Access Compliance Report

Public Rights-of-Way

(Curb Ramps)

Intersection ID: 54422	Main Street: LISMORE_LN	Cross Street: KILKENNY_DR	Location: SE
ADA ID: B7595EEF1F25	Ramp Type: Directional1	Initial Pass/Fail: Pass	Overall Compliance: No
Severity Score: 15.25			
Codes/Mitigation Info/Possible Solution		Field Measurements/Component Compliance

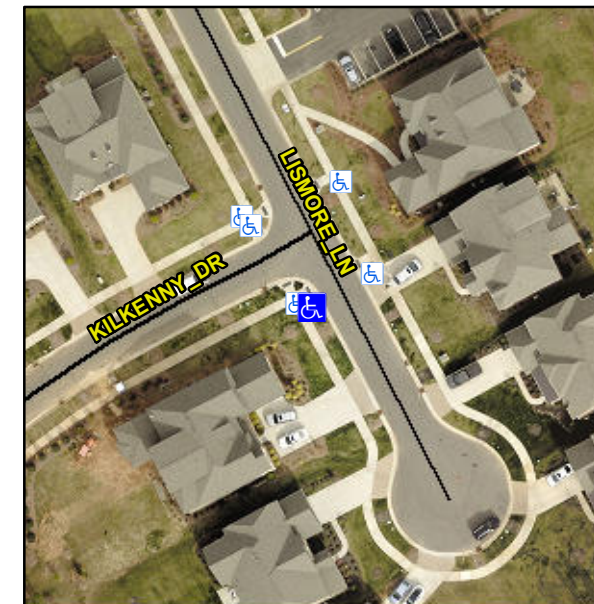
R304.5.3, R302.7.2

Compliance	Description	Data	Compliance	Description	Data
N/A	Ramp Length (in)	81.0	Yes	Grade Break?	Yes
Yes	Ramp Width (in)	59.0	No	Grade Break Slope (%)	9.4
Yes	Ramp Slope (%)	7.2	Yes	Grade Break XSlope (%)	0.2
No	Ramp XSlope (%)	3.1			
N/A	Flare Type LT	N/A	N/A	Flare Type RT	N/A
N/A	Flare Slope LT (%)	3.2	N/A	Flare Slope RT (%)	13.0
N/A	Flare Traversable LT?	No	N/A	Flare Traversable RT?	No
Yes	Landing Length (in)	59.5	Yes	DWS Provided?	Yes
Yes	Landing Width (in)	59.0	Yes	DWS Contrast?	Yes
Yes	Landing Slope (%)	0.2	Yes	DWS Length (in)	24.0
Yes	Landing X Slope (%)	0.1	Yes	DWS Full Width?	Yes
N/A	Landing Curb? (Y/N)	N/A	Yes	DWS Offset LT (in)	12.5
N/A	Shared Landing?	Yes	Yes	DWS Offset RT (in)	2.0
Yes	Gutter Ponding?	No	Yes	Gutter Slope (%)	4.1
No	Gutter Lip Ht (in)	2.0	Yes	Gutter X Slope (%)	2.1
N/A	Painted X Walk1?	No		Road Slope (%)	3.7
	X Walk 1 Direction	To NE		Road X Slope (%)	2.9
	X Walk 1 Width (in)	N/A		Clear Space?	Yes

X Walk 1 Slope (%)	3.7	N/A	Clear Space to XWalk (in)	N/A
	X Walk 1 X Slope (%)	2.9	Yes	Storm Grate/Utility Hazard?	No
N/A	Ramp inside XWalk1?	N/A		Storm Grate/Utility Type	
Yes	Any Obstructions?	No			N/A
	Obstruction Type		Yes	Surface Condition? (G/P)	Good
			N/A	Curb Slope (%)	9.0

**Remove & Replace Entire Ramp.
Grind Gutter Lip.**
